## 2.2 148 - 150.05 MHz Band

## **Technical Appendix B - Frequency Coordination Issues**

Figure A-3 - The "LEOAC-15" Spectrum Sharing Plan for the 148-150.05 MHz Band

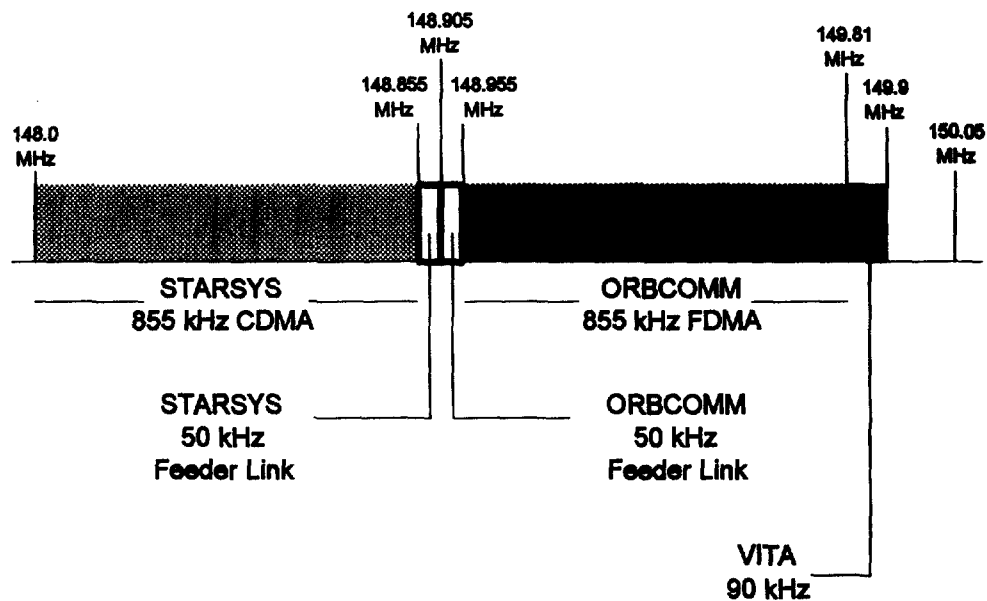
This band has been proposed to be used for the Earth-to-space feeder links of STARSYS (50 kHz) and ORBCOMM (50 kHz), and the Earth-to-space links of VITA (90 kHz). In addition the STARSYS mobile-to-satellite links are contained in a 855 kHz band that is foreseen to be dedicated to CDMA, and the corresponding ORBCOMM links in a separate 855 kHz band dedicated to FDMA systems. The 150 kHz band from 149.9-150.05 kHz (currently used by TRANSIT) is not expected to be occupied by the current applicants <sup>6</sup>. Figure A-3 shows the spectrum sharing plan for this frequency band as proposed by the current applicants.

As there is more bandwidth available in this band compared to the 137-138 MHz band, it is an obvious candidate for the additional accommodation of the relatively narrow-band feeder links for the LEO systems, as evidenced by the proposals from the existing applicants. For this

**Figure A-4 - Proposed Spectrum Sharing Plan for the 148-150.05 MHz Band**

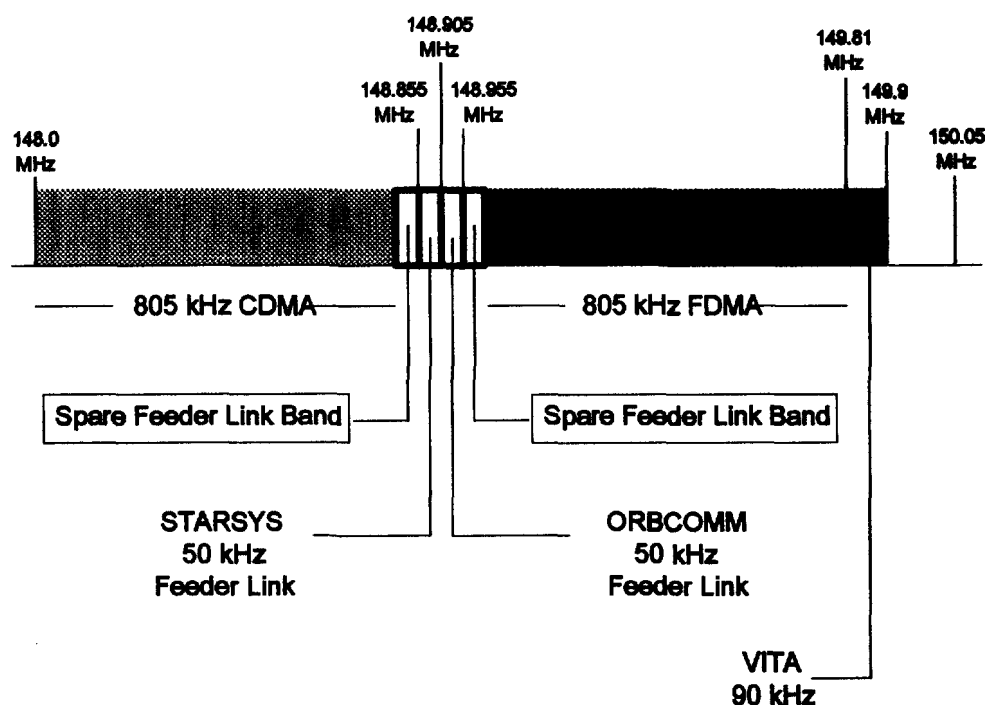
reason it is important that accommodation should also be made for some additional narrow-band feeder link channels to be used by future applicants. This could be achieved without seriously impacting the capacity of any of the existing licensees. Figure A-4 shows the proposed new spectrum plan with provision for two additional feeder links for future systems. Note that the wideband CDMA and FDMA regions of the band have been modestly reduced from 855 kHz to 805 kHz bandwidth, which will result in no more than a 6% reduction in the capacity of these segments.
